re: OU 1 Wetlands Mitigation

TO: Bill Fraser  
FROM: Bradley Miller  
COPY: Gary Kleeman  
RE: Comments on the September 14, 1992 Letter from DOE  
Addressing Wetland Mitigation for the French Drain  
Impacts at Rocky Flats  
DATE: September 21, 1992

attachment

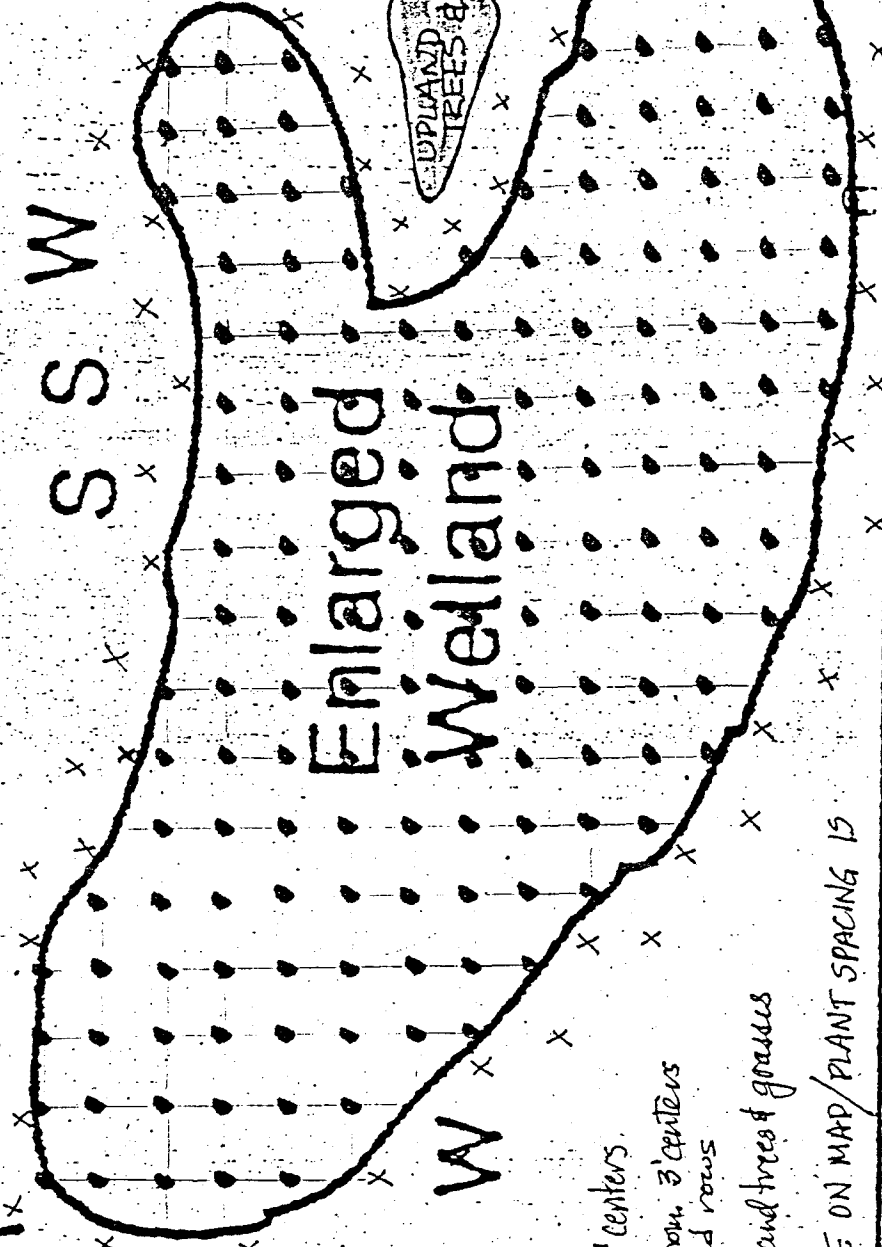
I have developed a mitigation planting plan based on the map of area which was part of the September 3, 1992 letter from DOE. I have drawn various areas of cattail, willow, and upland tree and grass planting. This map is attached for your reference. The willows are intended to be planted in two rows around the periphery of the wetland in staggered rows on nominal three foot centers such that the cut ends of the willows will be within the zone of soil saturation. The mitigation plan must also include a monitoring plan to verify the continued existence of the areal extent of wetland and characterize the overall health and the ability of the wetland to perform its functions. The monitoring plan should be implemented for at least five years with

maintenance being performed, as necessary, to achieve the mitigation goals. In addition to the reporting portion of the monitoring plan identified above, the plan should include photographs taken from set locations in set directions showing the wetland mitigation area.

Provided DOE agrees with the attached design of the mitigation plan, the areas of vegetative material collection are identified, the collection densities are specified and are acceptable, and the monitoring and maintenance provisions listed above are included, I see no reason why I would not recommend approval of the wetland mitigation plan.
